# Raidha Collection Ltd (Extension)

Zamirdia, Valuka, Mymensingh

2 November 2023

## 2. Observations:

**Observation-3:** Lack of lateral stability of steel rafter. (Wastage Godown)

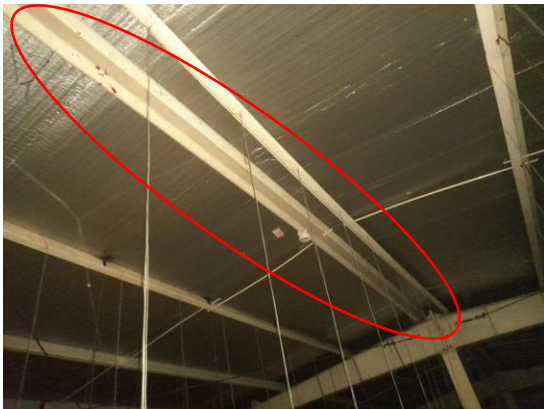
Missing compression strut

No vertical or Horizontal bracing

**Description:** Portal frame is provided along short direction. Load transfer media (compression strut) and resisting system (bracing) were not available along long direction. Therefore, lateral stability of steel rafter along long direction is questionable. The building engineer is required to check the lateral stability of the structure.

| Observation                                                          | Action Plan                                                                                                         | Timeline        |
|----------------------------------------------------------------------|---------------------------------------------------------------------------------------------------------------------|-----------------|
| Lack of Lateral Stability of Steel Rafter. (Wastage Godown)          | The building engineer is required to check the lateral stability of the steel rafter.                               | within 6 weeks  |
| Lack of Lateral Stability of Steel Rafter. (Wastage Godown)          | Implement remediation work if required.                                                                             | within 6 months |

**Observation-4:** Lack of Lateral Stability. (Stoll Shed)

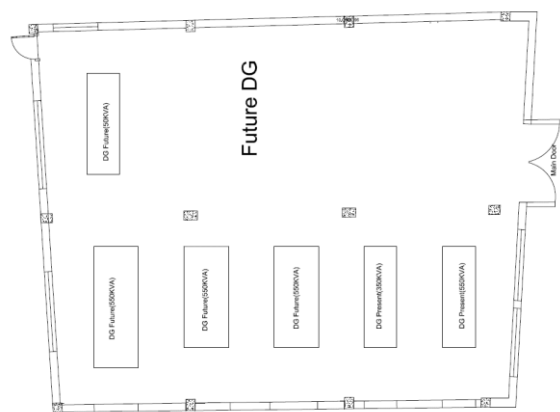
Missing compression strut

Cable bracing on roof

**Description:** Portal frame is provided along short direction. Load transfer media (compression strut) was not available along long direction. Therefore, lateral stability system along long direction is incomplete. The building engineer is required to check the lateral stability of the structure.

| Observation                                                          | Action Plan                                                                                                         | Timeline        |
|----------------------------------------------------------------------|---------------------------------------------------------------------------------------------------------------------|-----------------|
| Lack of Lateral Stability. (Stoll Shed)                              | Building engineer is required to check the lateral stability of the shed.                                           | within 6 weeks  |
| Lack of Lateral Stability. (Stoll Shed)                              | Implement remediation work if required.                                                                             | within 6 months |

**Observation-5:** Lack of information in as-built drawing. (Diesel Generator Building)

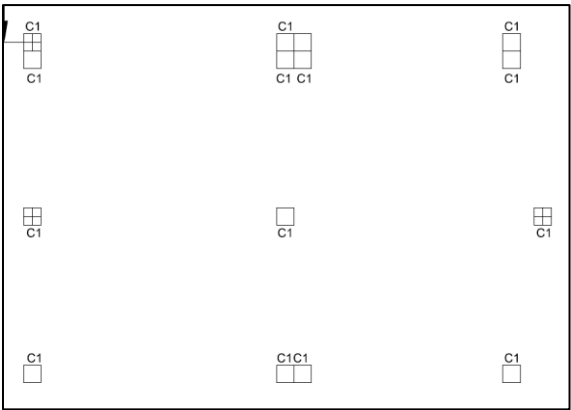
Roop top chiller

**Description:** In architectural drawing, roof layout plan and details for existing chiller on roof was not available for Diesel Generator Building. Building engineer is required to update as-built drawing incorporating all structural details of this Building.

| Observation                                                          | Action Plan                                                                                                         | Timeline        |
|----------------------------------------------------------------------|---------------------------------------------------------------------------------------------------------------------|-----------------|
| Lack of information in as-built drawing. (Diesel Generator Building) | Building engineer is required to update as-built drawing incorporating all structural details of this Building.     | within 6 weeks  |
